Authorized Field Change

AFC G-05908

Subject: All FE 300 Bus Models Built Between March 1, 2004 and April 5, 2005 with Allison Automatic Transmissions May Develop a Transmission Fluid Leak in the Jumper Hose Between the Radiator In-Tank Transmission Cooler and the Transmission Air to Oil Cooler

Model: FE 300

Figure 2 Transmission Cooler Jumper Hose Location and Components

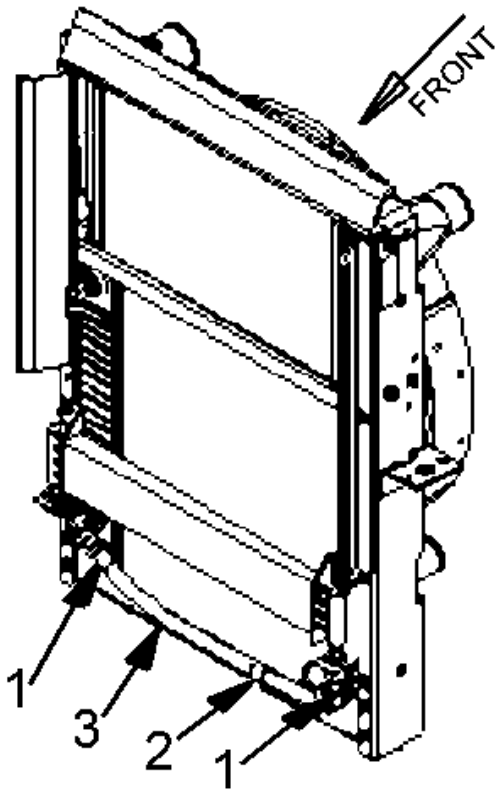
The transmission cooler jumper hose straight flare fitting was over-crimped by the supplier causing radial cracks in the interior layer of the hose. With time the transmission fluid may penetrate the hose layers and cause degradation.

1. See Figure 3 for Enlarged View
2. See Figure 4 for Enlarged View
2. Position a suitable clean container below the jumper hose flare fitting on the passenger entry side of the bus. Disconnect the jumper flare hose fitting (Figure 2, Item 1) and allow the transmission fluid to drain into the container.
3. Remove the p-clip (Figure 2, Item 2), disconnect the remaining hose flare fitting and remove the jumper hose.
4. Install the new jumper hose and reinstall the p-clip following the previous Steps in reverse order. Tighten the jumper hose flare fittings to 52 to 57 Lbf-ft (70 to 77 Nm).
